A/NE-PK/234

Response to the Transport Department' s comments

LAYOUT PLAN

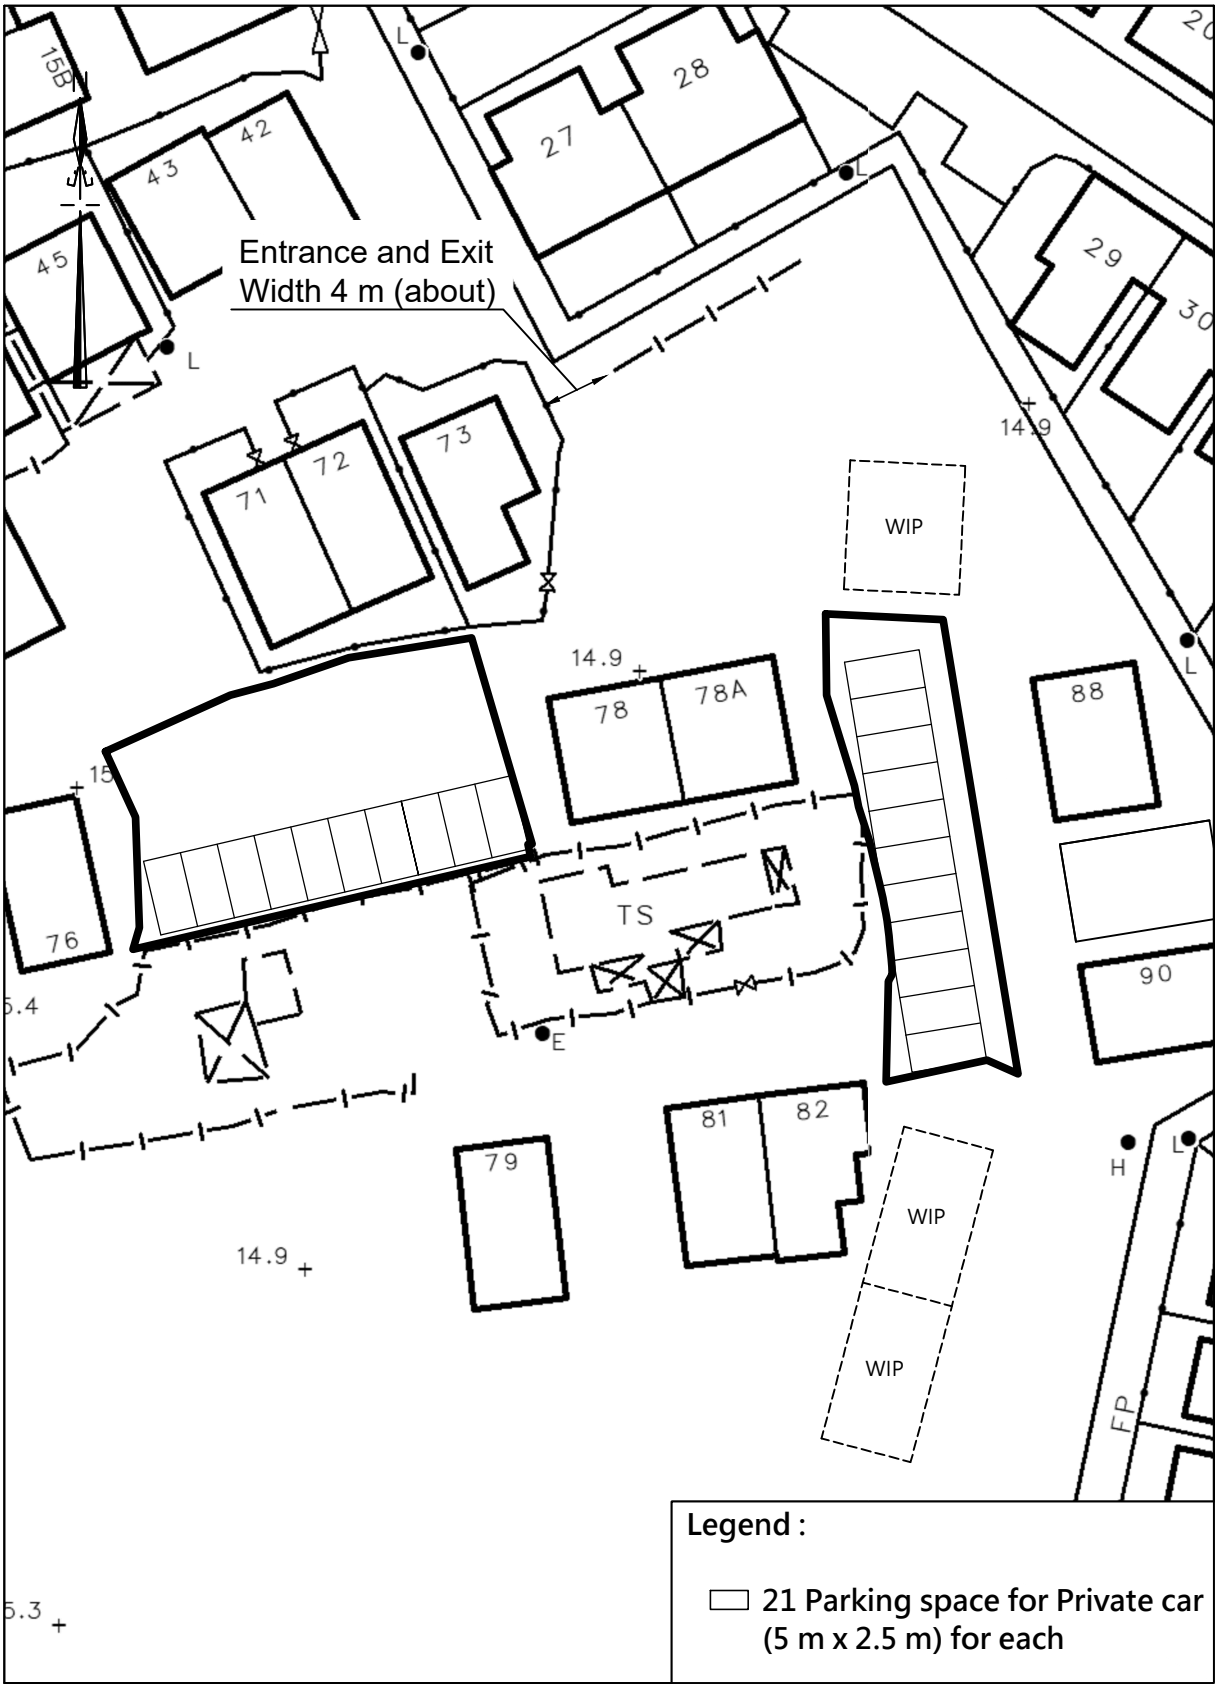
Response to the Planning Department' s comments

1. Please refer to the legend on the layout plan for the parking space dimensions.
2. The 5 meters wide section of road will be used as a buffer zone, and parking will be prohibited. A sign warning drivers to watch for oncoming traffic will be installed, along with speed humps to ensure that vehicles travel at a safe speed. The application site was previously used as a car park for private cars only, and no clash accidents have ever occurred there.

3. We will install sign boards at the road bends to remind road users to watch out for vehicles, and aconvex mirrors to help them see the road conditions clearly.

4. We will ensure that no vehicle is allowed to queue back to or reverse onto / from public road at any time during the planning approval period.
5. The local village access road leading to the site from Yu Tai Road is not managed by this Department. We will obtain consent from relevant land owners and maintenance authorities on using the local village access road.

1. The parking spaces at the application site are currently unregulated. If approval is granted, all parking spaces will be laid out in accordance with the layout plan submitted with application
